NUMBER: M20-43

SUBJECT: STATIC PRESSURE SYSTEM MODIFICATION TO
ELIMINATE MOISTURE ACCUMULATION IN SYSTEM

AFFECTED: All M20 Series models and serial numbers prior to:
M20C - S/N 20-1257
M20J - S/N 24-0787
M20K - S/N 25-0101

FIGURE 1

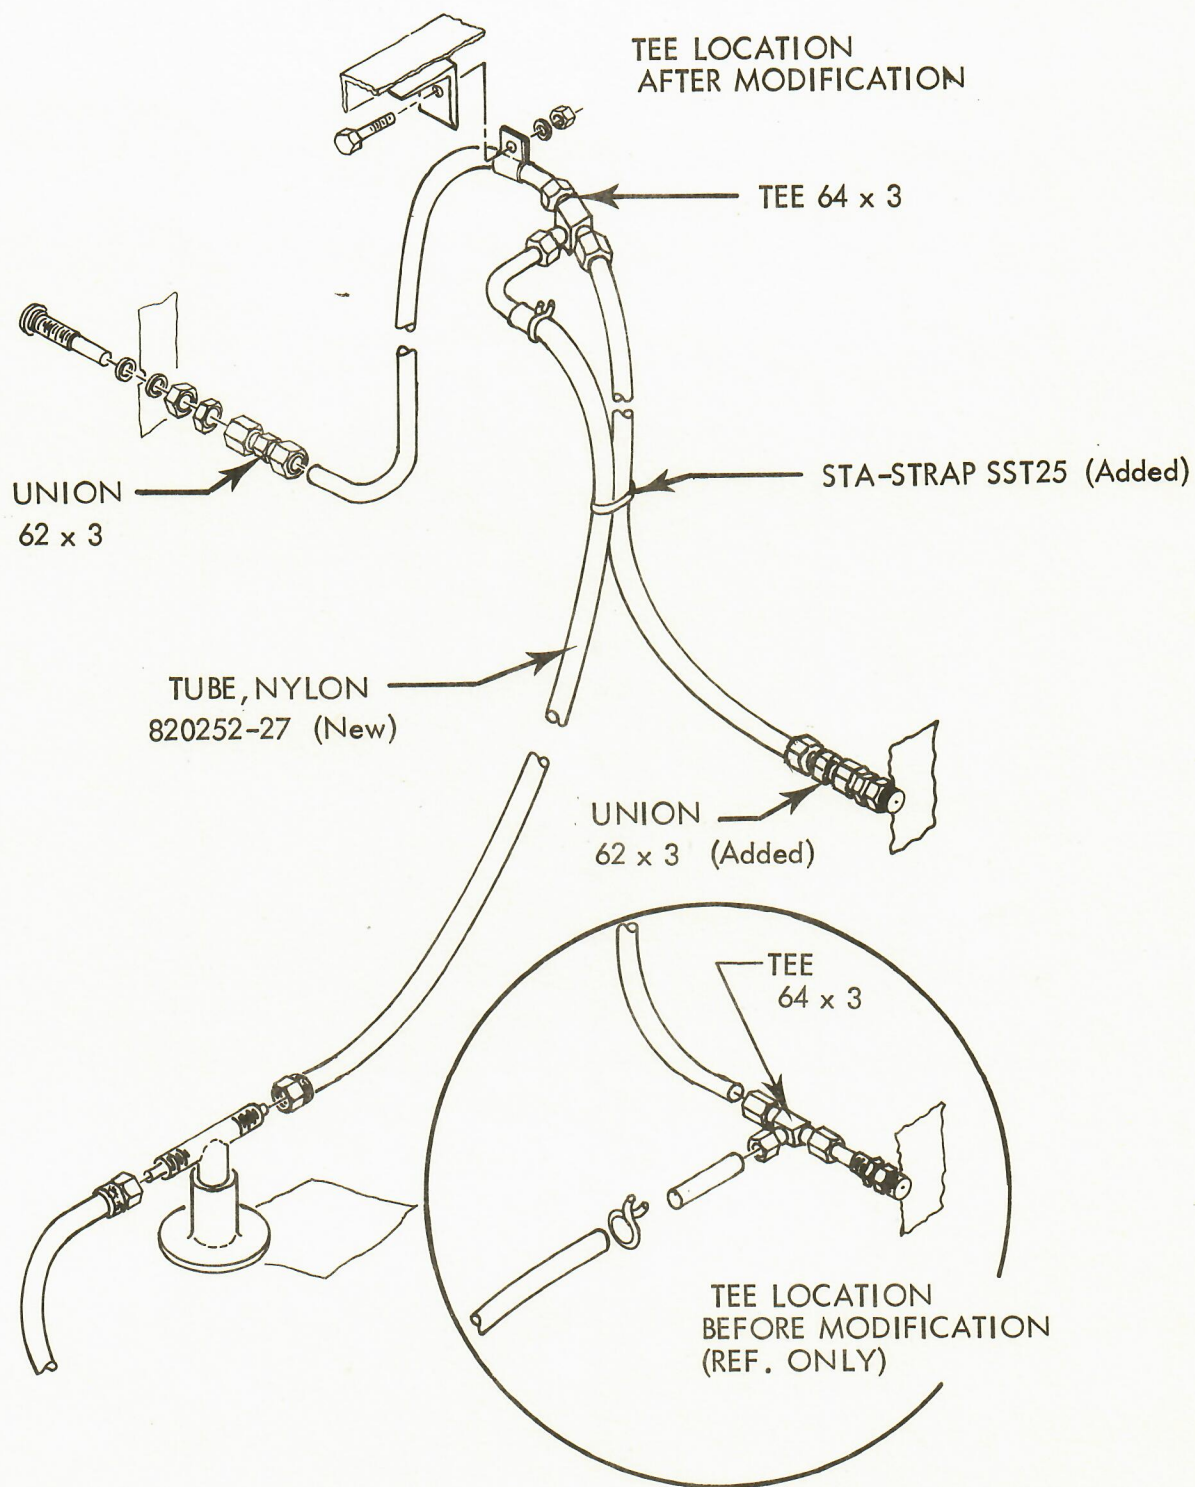
INTRODUCTION: Certain environmental conditions may cause moisture to accumulate within the static pressure system. This accumulation of moisture can cause false altitude, vertical speed and airspeed indications to the pilot. It is recommended that the static pressure system be modified as described in this Service Instruction.

- INSTRUCTION:
- 1) Remove static system tube assembly connected to static port buttons located on both sides of the tailcone assembly. Remove tube from clamp on longeron located at top of tailcone assembly. Remove the nylon tube from the drain valve located on bottom skin of tailcone assembly. The antenna wire clamp must be loosened from nylon tube prior to removal. Slide through bulkheads on older models.
 - 2) Disassemble 64 X 3 tee from tube assembly leaving nuts and ferrules on tube end and on static button tube end. Tag this end of tube before removal of tee for a dimension to be addressed later.

Disconnect short tube from tee and leave the nut and ferrule attached.
 - 3) Lay the long tube assembly on flat surface and measure along center line of tube, starting from opposite end of tube where the 64 X 3 tee was connected, 23.5 inches and cut tube in two with tube cutter. Deburr both ends tubes now cut and clear filings from tubes.

- 4) Lay short tube on flat surface and bend a 90° angle in tube so each leg is equal in length. Use a bend radius of approximately 1 inch while bending being careful not to collapse tube walls.

- 5) Install 64 X 3 tee between the two cut sections of old tube assy using the nuts and ferrules from the 62 X 3 union supplied in the kit at this new tee location. The tee must be located in a horizontal plane, when installed on aircraft, with third leg facing forward to accept new aluminum and nylon tubes. Connect the short aluminum tube to tee with tube leg pointing toward left side of aircraft. Connect nylon tube, included in kit, to this leg of tube using the spring clamp removed from old installation. Clamp nylon tube to adjacent section of aluminum tube attached to static button, with the SST25 sta-strap included in the kit.

- 6) Completed assembly is now ready to install onto aircraft. Connect the assembly to the 62 X 3 union already connected to right hand side of aircraft and using the new 62 X 3 union supplied in kit, connect the assembly to the static button on the left side of the aircraft using the old nuts and ferrules already attached. Reconnect the clamp at the top of the tailcone assy and the antenna wire clamp at their existing locations. Connect the nylon tube to the static drain valve finger tight plus 1/4 turn. Tighten all nuts at the new connections to a torque of 15-20 inch pounds. Do not over tighten, damage to ferrules or tube may result.
